| Office Action Summary | Application No. 10/712,770 | Applicant(s) NAGAYOSHI ET AL. | |

DETAILED ACTION

Figure A

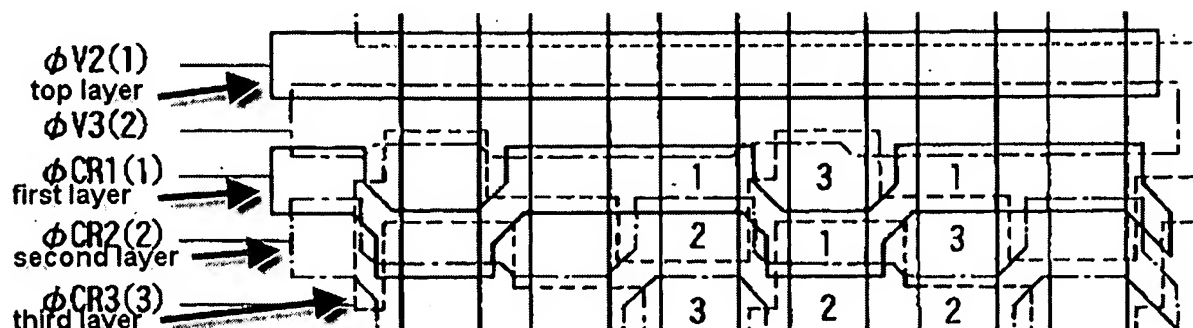
As to claim **25**, see the rejection of claim **1** and note that Iizuka further teaches the solid state image sensing device according to claim **1**, wherein the vertical transfer parts have at least three layers of electrode films (see Fig. A below), and the transfer electrodes provided independently of those of vertical last stages of the other columns are formed of at least one of layers of electrode films that includes a top layer (see Fig. A below).
